**Amendments to the Drawings:**

*Application Serial No.: 10/768,150*  
*Art Unit: 3751*

*Attorney Docket No. 24024.00*  
*Confirmation No. 6427*

*Fig. 2*

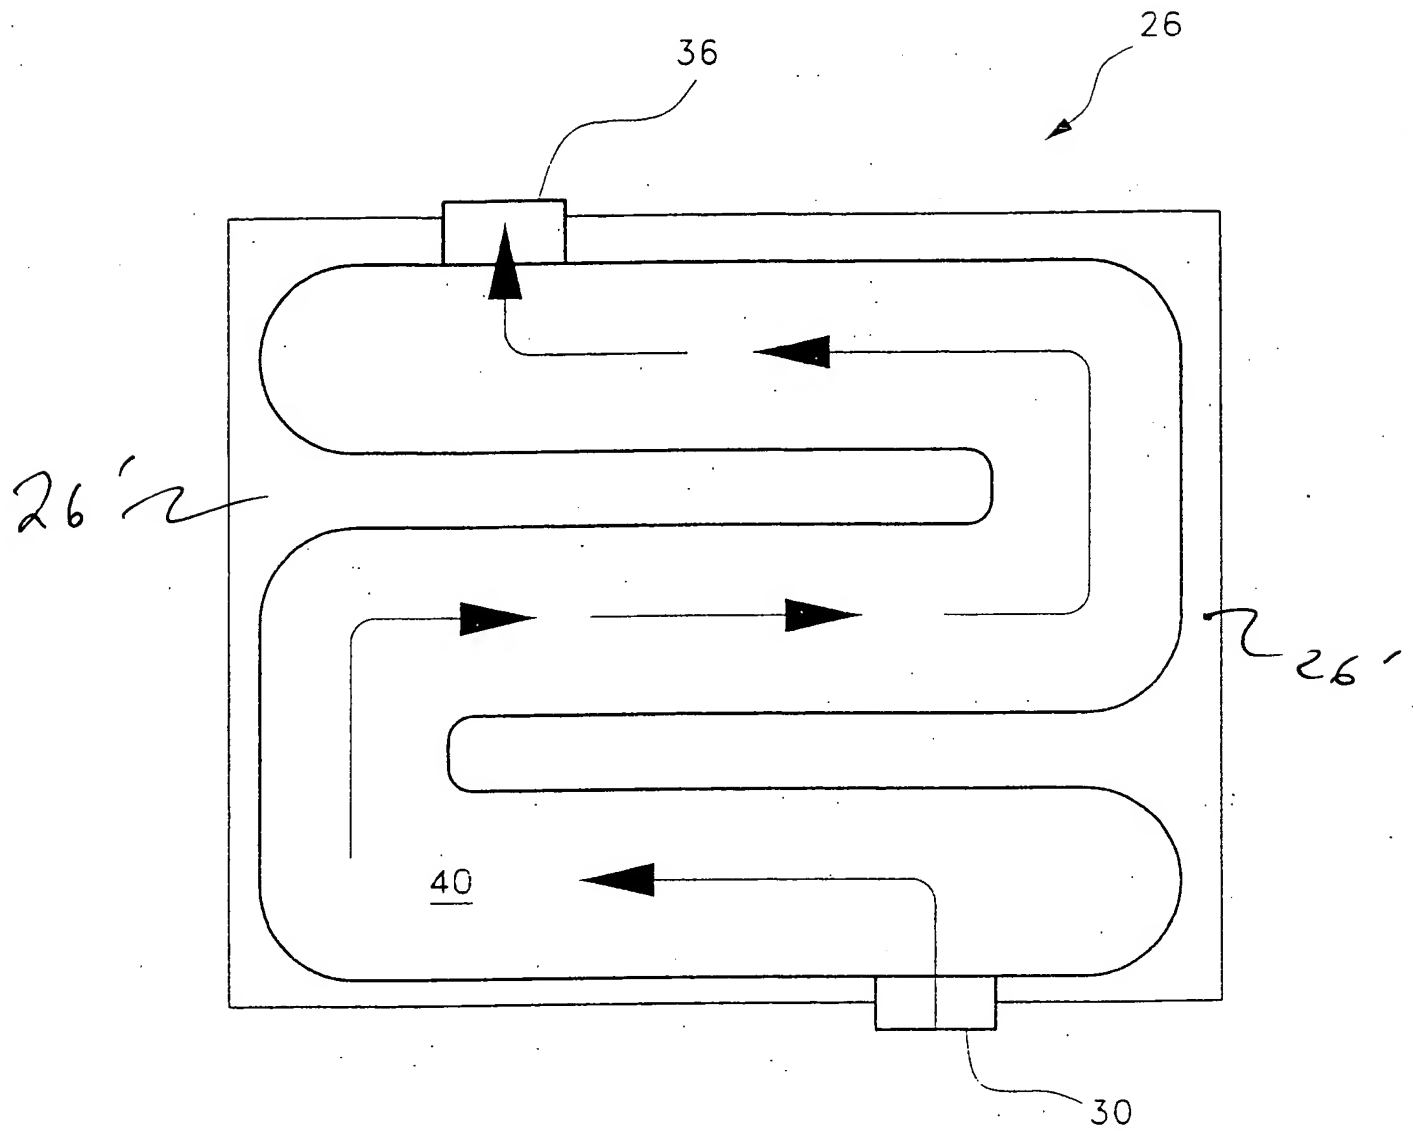
A proposed drawing change is submitted herewith. Proposed changes are shown in red. The attached sheet of drawings includes changes to Fig. 2. This sheet, which includes Fig. 2, replaces the original sheet including Fig. 2. In Fig. 2, previously omitted reference character -- 26' -- has been added.
